# UNITED STATES PATENT AND TRADEMARK OFFICE

| APPLICATION NO.   | FILING DATE | FIRST NAMED INVENTOR | ATTORNEY DOCKET NO.           | CONFIRMATION NO.       |
|---|-------------|----------------------|-------------------------------|------------------------|
| 10/518,748  | 07/26/2005  | Hermann Raabe        | 095309.55705US                | 1320                   |

| <b>Office Action Summary</b> | <b>Application No.</b><br>10/518,748 | <b>Applicant(s)</b><br>RAABE ET AL. |  |

## DETAILED ACTION

Figure 1. Ganser's torque-transmitting joint.

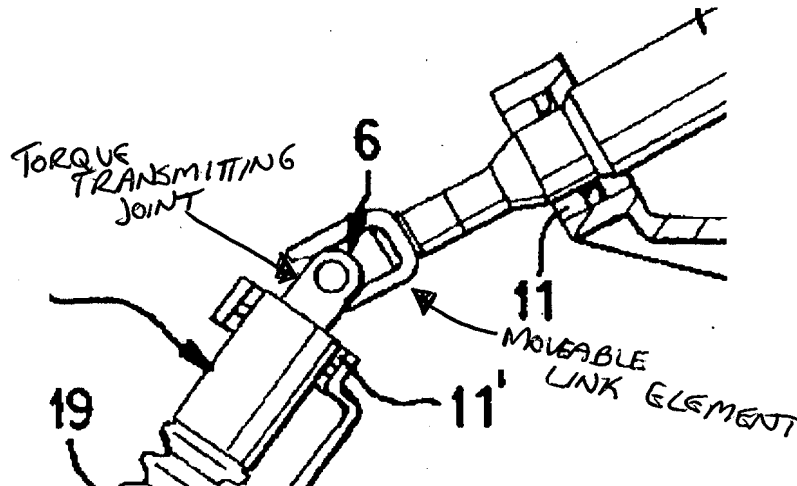
Re clm 1, Ganser discloses a steering spindle (8) which bears a steering wheel (2), a steering shaft (5) connected to the steering spindle (8), a torque-transmitting joint (See Fig 1 below) forming the connection between the steering spindle (8) and the steering shaft (5) and a second moveable link element (Fig 1 below).

Ganser does not disclose that said second moveable link element is an axially moveable for axial length compensation comprising at least one coupling member with two parallel axes of rotation, and a spigot cross element being coupled to the end of the steering spindle which lies opposite the steering wheel, one axis of the spigot cross element forming an axis of rotation for the coupling member, wherein the steering shaft has a flange which ends at a distance from the longitudinal axis of the steering shaft, the flange executing a pivot movement about the upper axis of rotation of the coupling member.

Figure 2. Bouchard's extensible joint for motor vehicles. The examiner has added character references to better explain the drawing.

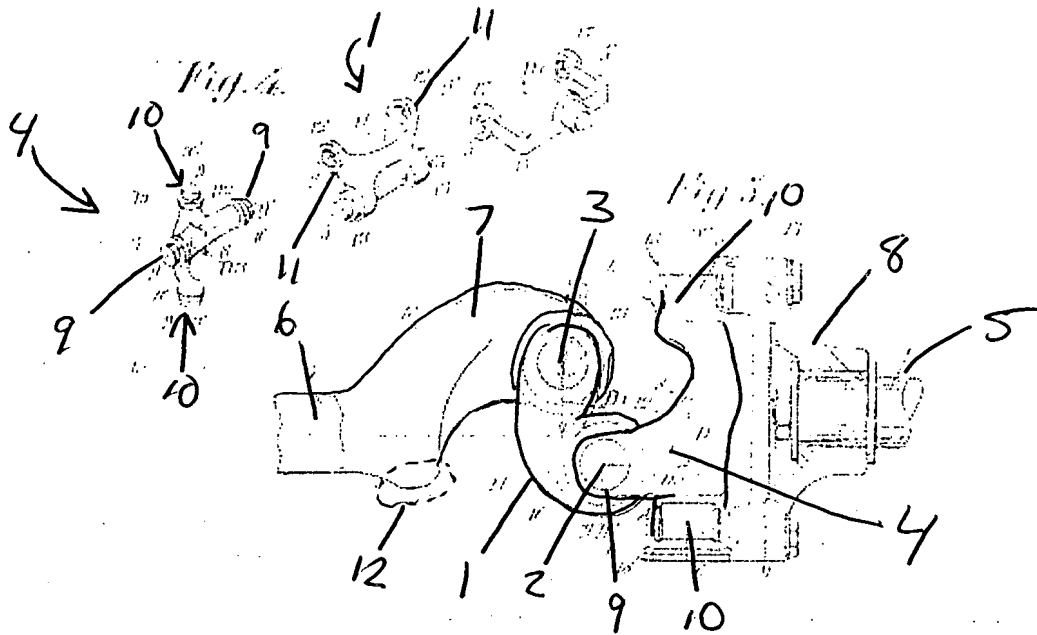
Bouchard teaches a moveable link element (Fig 4/5 or see Fig 2 below) for the purpose of allowing for relative variations of the orientations and respective axial

positions (col 1) comprising at least one coupling member (1) with two parallel axes of rotation (2,3), and a spigot cross element (4) being coupled to the end of the steering spindle (5) which lies opposite the steering wheel, one axis of the spigot cross element (4) forming an axis of rotation (2) for the coupling member (1), wherein the steering shaft (6) has a flange (7) which ends at a distance from the longitudinal axis of the steering shaft, the flange executing a pivot movement about the upper axis of rotation (3) of the coupling member (1).

It would have been obvious to one having ordinary skill in the art at the time of the invention to modify the teachings of Ganser and provide an axially moveable link element, as taught by Bouchard, for the purpose of allowing for relative variations of the orientations and respective axial positions.

Re clm. 2, Bouchard discloses the spigot cross element (4) being mounted in a forked joint (8). From the combined invention of Ganser and Bouchard discussed above said forked joint will be arranged at the end of the steering spindle which lies opposite the steering wheel.

Re clm. 3, Bouchard discloses two transverse spigots (9) of the spigot cross element (4) form a transverse bolt of the coupling member (1).

Re clm. 4, Bouchard discloses two longitudinal spigots (10) of the spigot cross element (4) form a pivot axis of the forked joint (8).

Re clm. 5, Bouchard discloses that the coupling member (1) comprises two side plates (11) through which two transverse bolts pass, the transverse bolts form the axes of rotation (2,3) of the coupling member (1).

Re clms. 6, 8, 10, 12 and 14, Bouchard discloses the flange being provided with an additional mass (12).
